# Access Compliance Report

## Public Rights-of-Way

### (Curb Ramps)

| Intersection ID: 8932 | Main Street: JENNINGS_ST | Cross Street: N/A       | Location: SW           |

| ADA ID: E0E7B1AD56E8  | Ramp Type: PerpDiag      | Initial Pass/Fail: Fail | Overall Compliance: No |

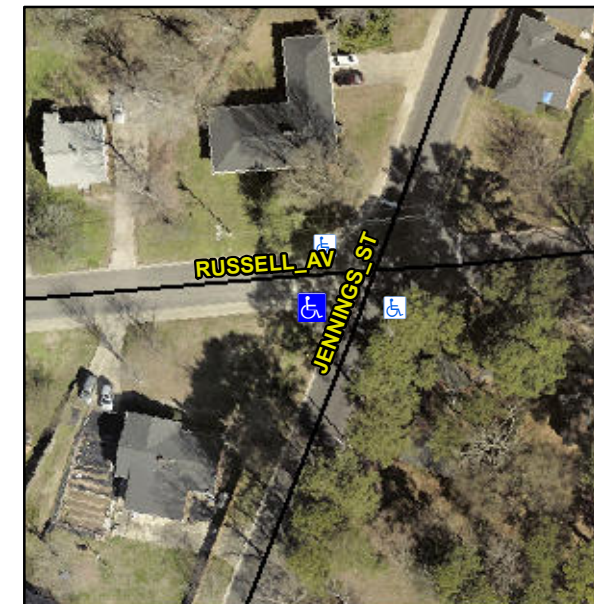
**Not Found, R304.2.2, R304.5.3**

| Compliance | Description           | Data | Compliance | Description                 | Data |
|------------|-----------------------|------|------------|-----------------------------|------|
| N/A        | Ramp Length (in)      | 66.0 | No         | Ramp Slope (%)              | 10.9 |
| Yes        | Ramp Width (in)       | 57.0 | No         | Ramp XSlope (%)             | 4.5  |

**Remove & Replace Curb Ramp With Two New Directional Ramps or Equivalent.**
